DESCRIPTION: (Must Be Unclassified)  
**Ltr re our 8-13-71 ltr ..furnishing**  
**addl info(answers to questions 2,3 & 4)**  
**on the partial refueling of Nine Mile**  
**Point reactor..answers to questins**

Your letter of August 13, 1971 requested additional information on the partial refueling of the Nine Mile Point reactor scheduled for September 19, 1971. Upon receipt of this letter, Niagara Mohawk immediately initiated the preparation of a response.

Information requested on the second, third, and fourth questions in your letter of August 13, 1971 is enclosed. The response to your first question, concerning the consequences of possible loading errors, is in final stages of preparation and will be forwarded promptly upon completion.

FIGURE 4-1

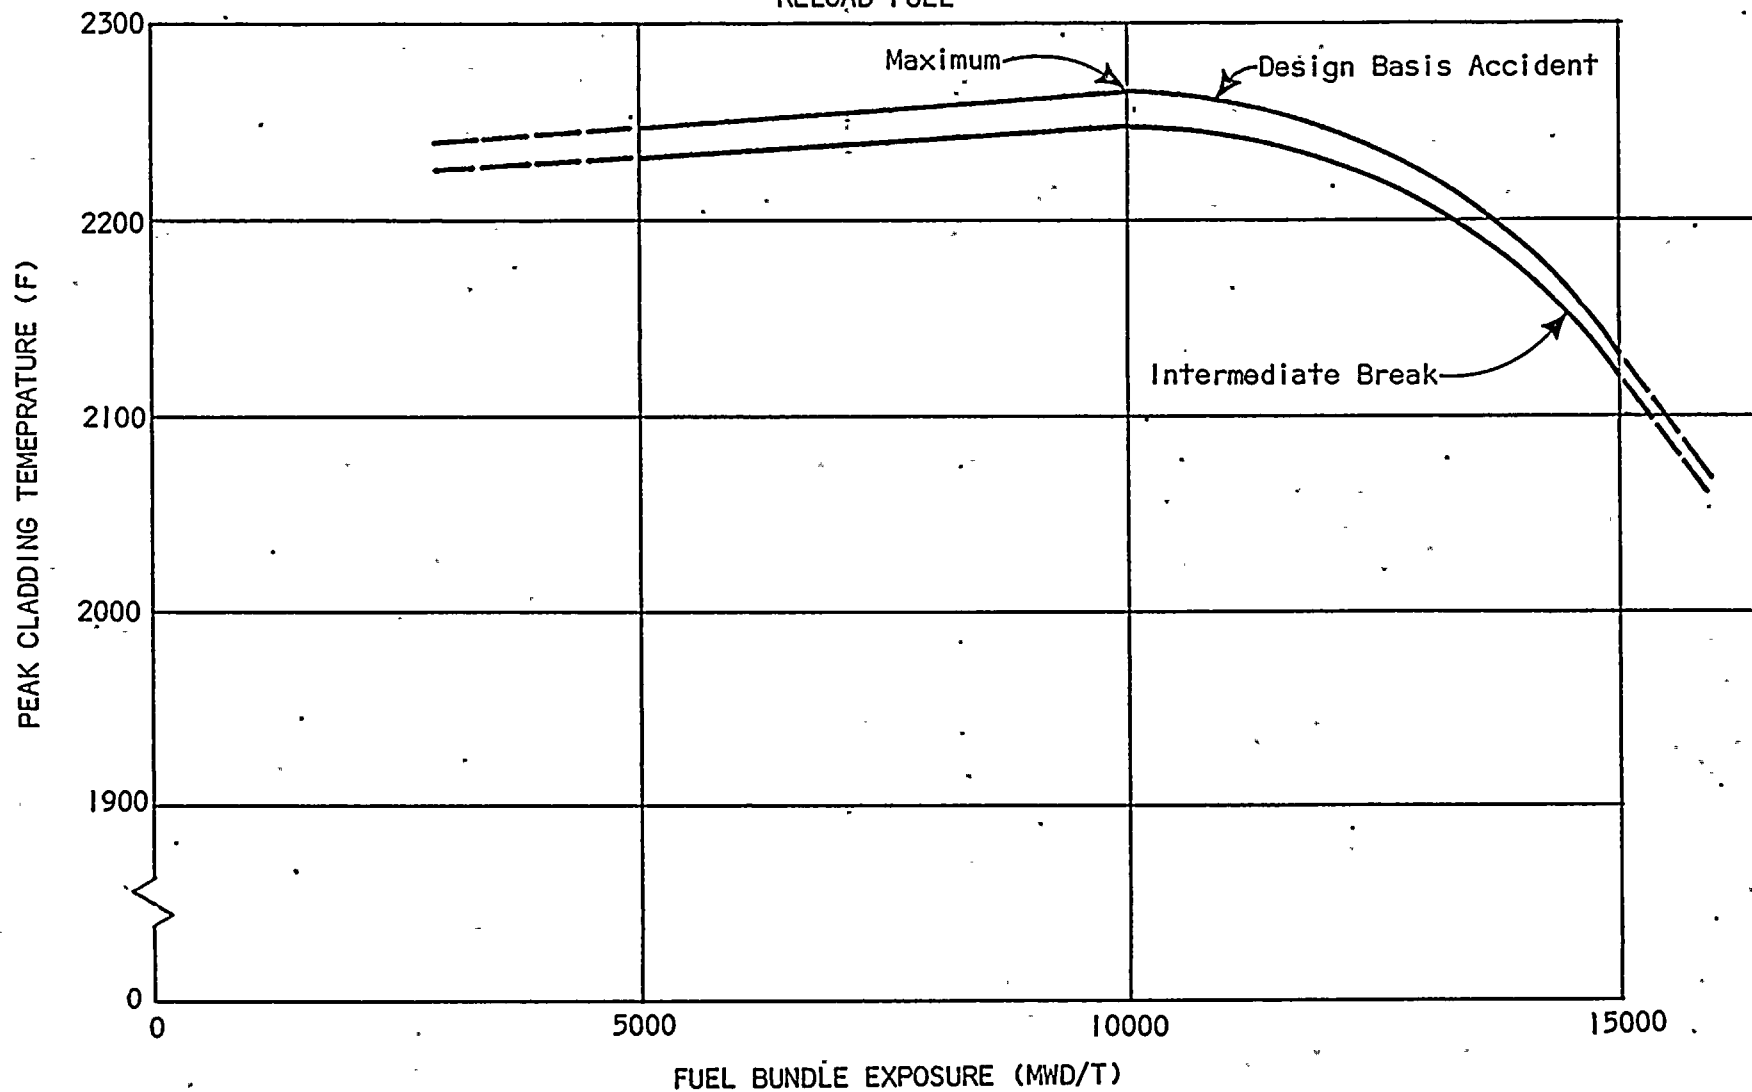
Describe in detail the effect of the proposed fuel on analytical results obtained from the study you are performing in response to our letter to you dated July 22, 1971, concerning the AEC interim acceptance criteria for the performance of emergency core cooling systems.

The same single-failure events described in our letter of August 20, 1971 to the Commission for the initial core fuel were used in the reload analyses and the complete range of peaking factors, from the beginning to the end of bundle life, was studied. Results are shown in Figure 4-1. The maximum peak clad temperature of the reloaded core occurs at 10,000 MWD/T, even though the highest local peaking factor is not then at its maximum. A maximum peak clad temperature of 2265F was obtained from this study for the design basis accident; the corresponding peak clad temperature for the worst case intermediate size break is 2245F. Clad embrittlement continues to be avoided for all breaks up to and including the design basis accident since the maximum local cladding oxidation is less than 7.0% for the reload core case. These data compare closely to those calculated for the initial core bundles. Thus, the Nine Mile Point reloaded core will continue to be in conformance with the Commission's Interim Acceptance Criteria when reload fuel of the type described in our letter of July 27, 1971 is employed at any location in the core.
